**JULY 25, 2014**

## **STAFF REPORT ADDENDUM III**

### **SPECIAL EXCEPTION AMENDMENT SEA 80-L/V-061-02**

**LORTON GREEN ENERGY PARK & DEBRIS LANDFILL**  
 SPECIAL EXCEPTION AMENDMENT  
 PHASING PLAN AND TABULATIONS  
 MONTGOMERY COUNTY, VIRGINIA  
 PROJECT NO. 2009-05-11

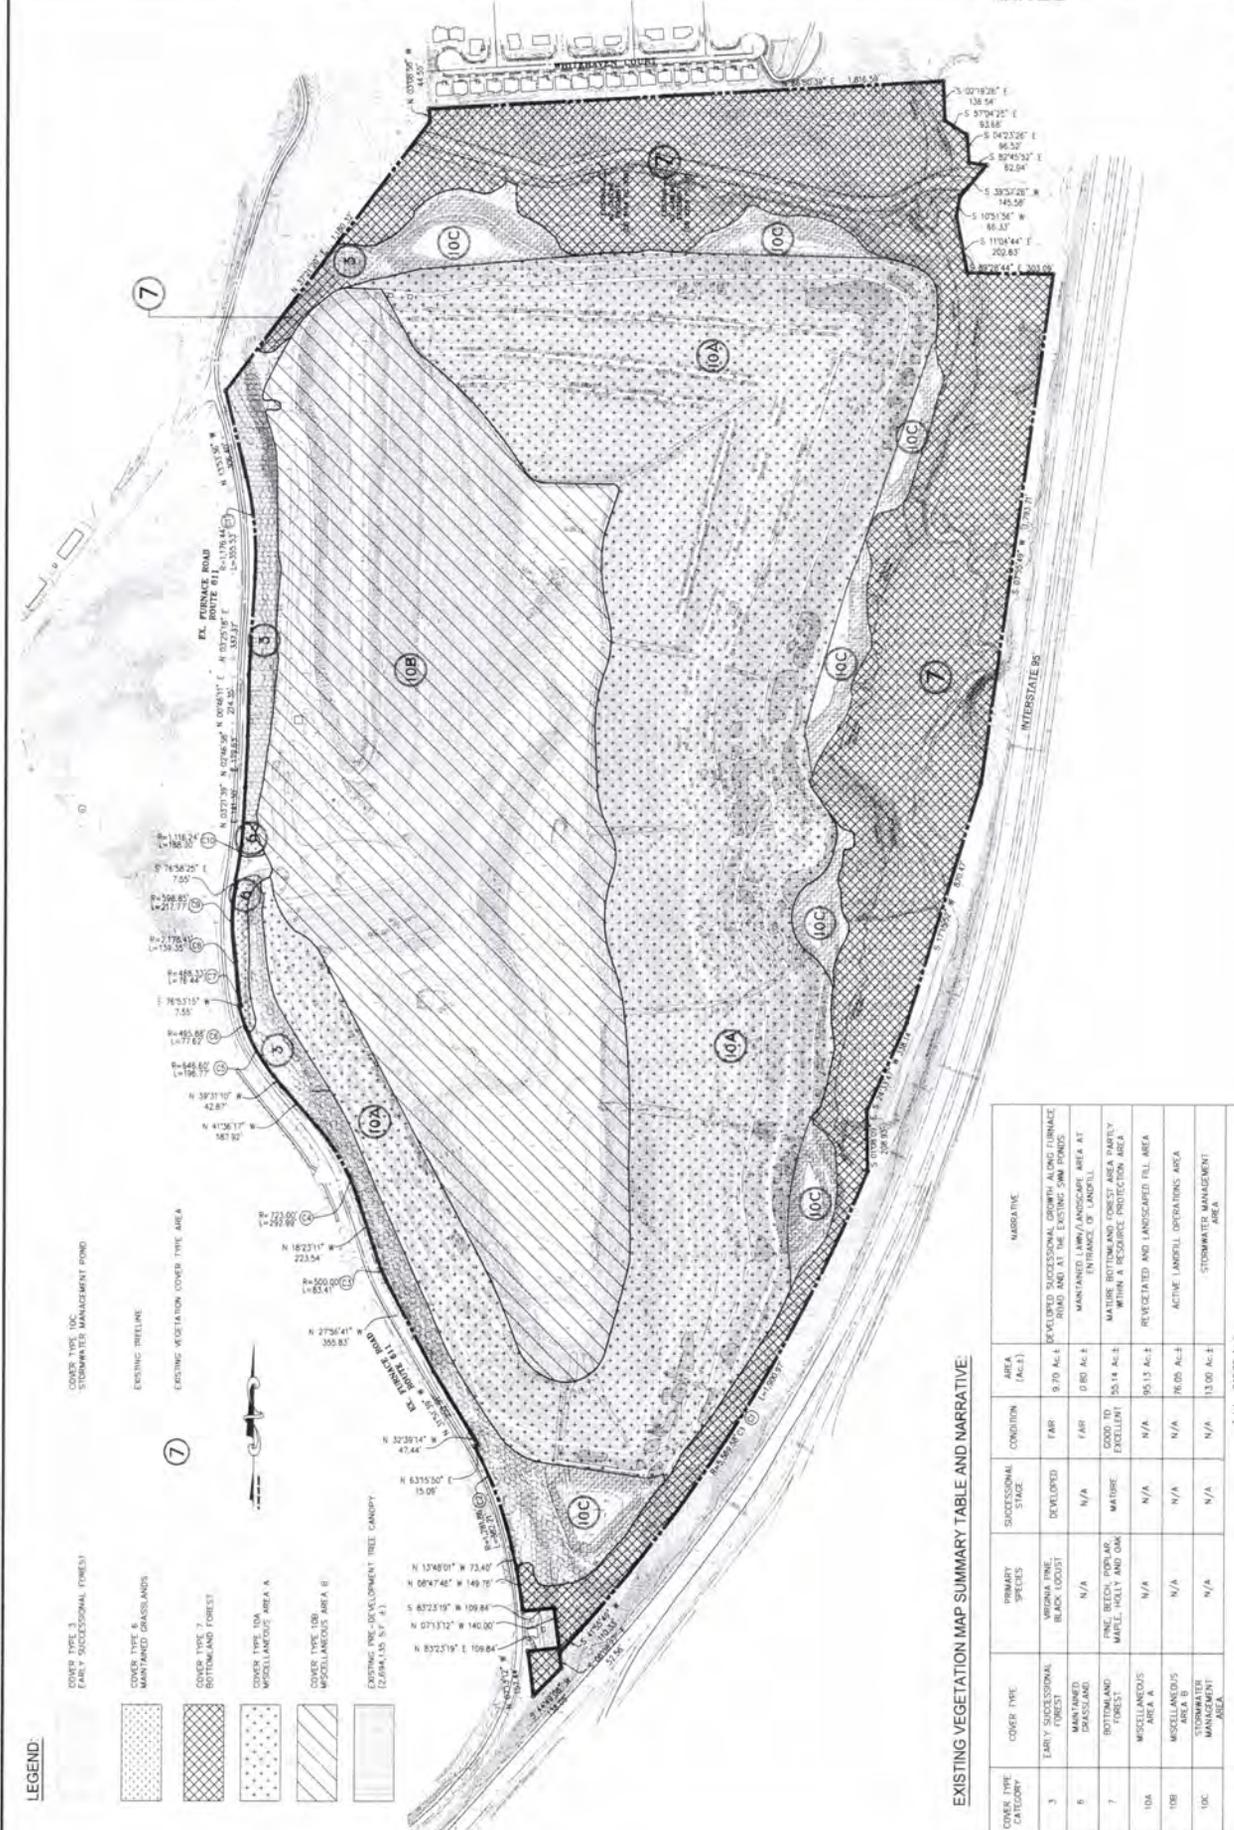
**Sheet 2 (Phasing Plan and Tabulations)**

- Revised the Phasing Plan and areas for the solar panels.
- Added a new stormwater basin in the eastern side of the landfill.
- Removed the Observation Point from the Site Tabulations.
- Revised the maximum height from 15 feet to 25 feet for the structures proposed for Phases 5 and 6.

DESIGNED BY: CAD  
CHECKED BY: NO  
DATE: MARCH 22, 2013  
SCALE: HWS AS SHOWN  
SHEET: 14 OF 47  
CD: NO. 584-801-17-001-2  
PROJECT: DEBRIS LANDFILL  
LAYOUT: 14  
FILE NO.: 050117-08-00

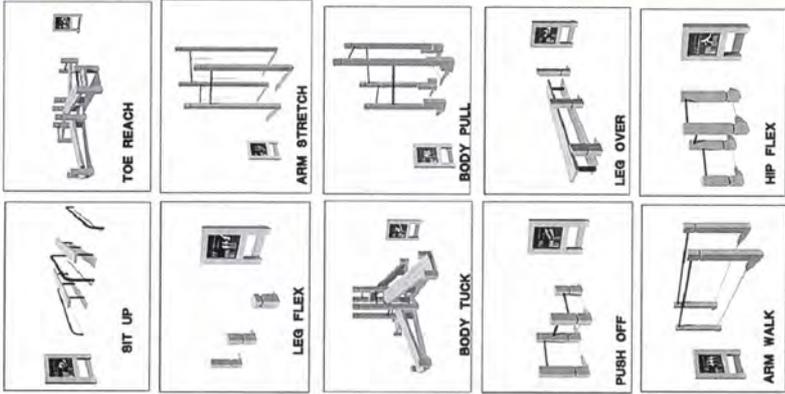
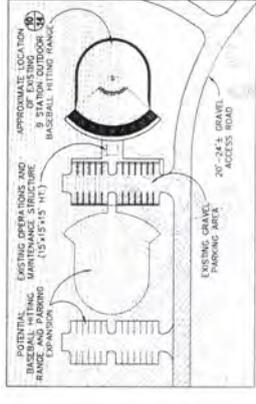
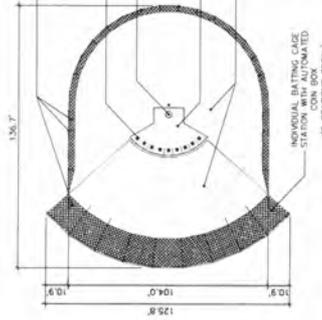
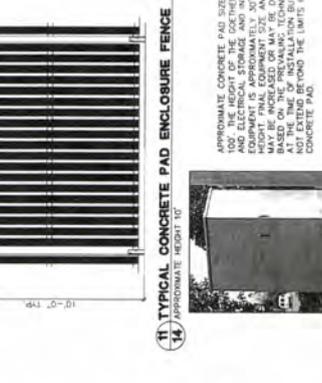
- Revised Detail 1 showing that the maximum height of the berm as 25 feet. Previously, the proposed maximum height of the berm was 70 feet.
- Revised Detail 6 showing the top elevation area of the landfill now is proposed to be approximately 20 acres. Previously it was proposed to be 50.2 acres based on a maximum berm height of 70 feet.
- Added the typical showing the approximately 5,000 square foot concrete pad

**LORTON GREEN ENERGY PARK & DEBRIS LANDFILL**  
 PHASE FIVE LANDFILL OPERATIONS TRUCK TRAFFIC CIRCULATION  
 SPECIAL EXCEPTION AMENDMENT

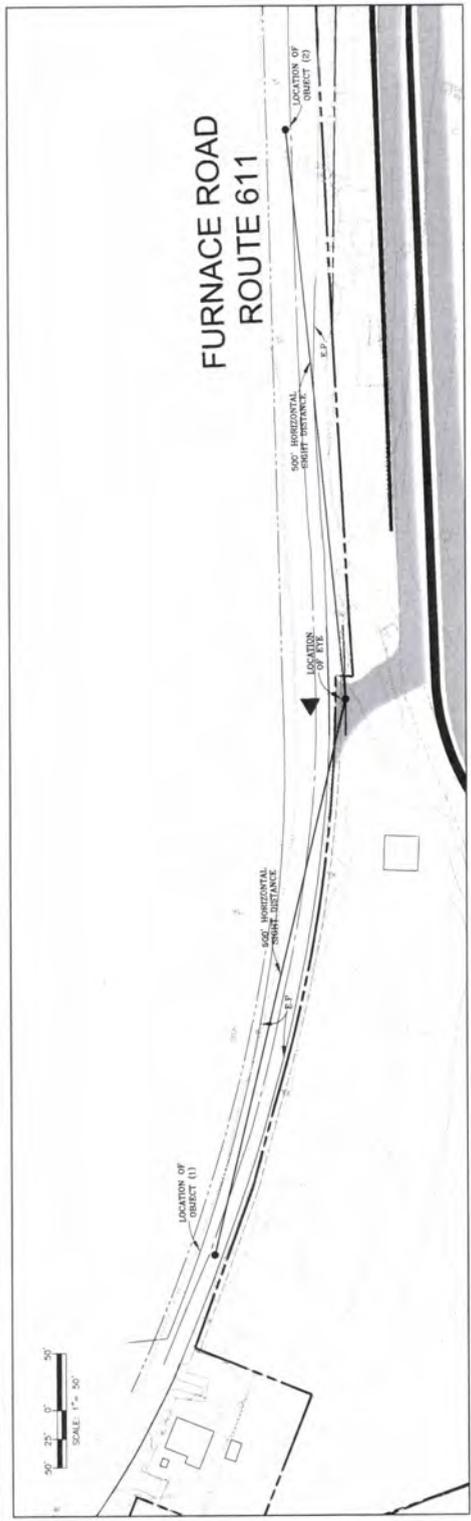
- Added clarification to Note #3 on Sheet 41 that trucks are limited to right turn in only.
- Added Note #4 to Phases 1-4 that at the northern entrance vehicles may enter and exit. Previously, trucks were limited to right turn in-only and left turn out-only. The change is due to the applicant's proposal to allow vehicles from the mixed waste reclamation facility.

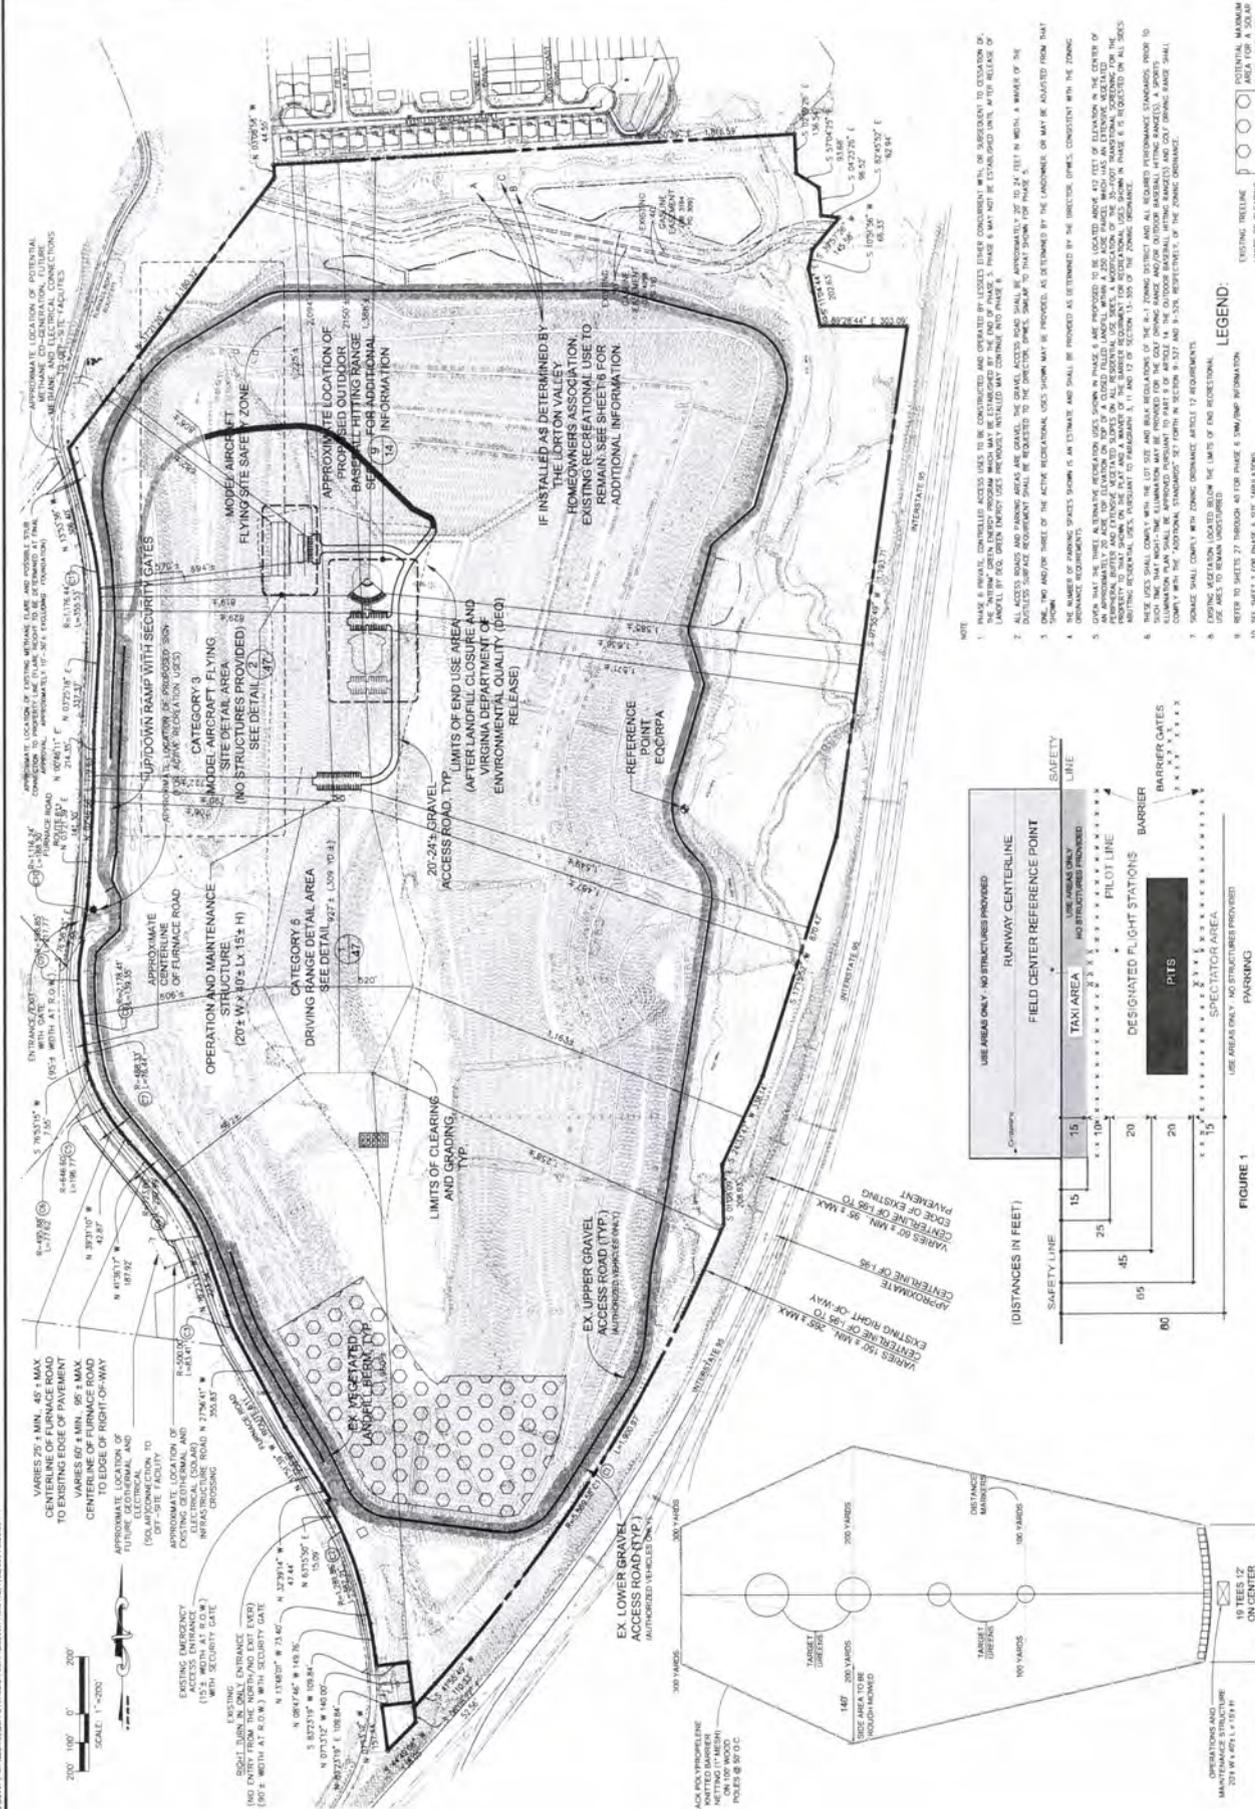
#### Sheet 47 (Phase 6)

- Reduced the number of golf driving range tees from 25 to 19 and the side area to be mowed from 160 feet to 140 feet in Detail 1.
- Revised the distances from the golf driving range, outdoor baseball hitting range, and radio controlled aircraft areas to the property line.
- Revised the final debris elevation from 395 feet above sea level to 412 feet and the top elevation area of the landfill from 50.2 acres to 20 acres in Note 5.
- Revised Note 12 that all Phase 6 traffic is allowed full movement at the main entrance. Previously, the applicant proposed traffic will be allowed to make left turns in and right turns out at the main entrance.
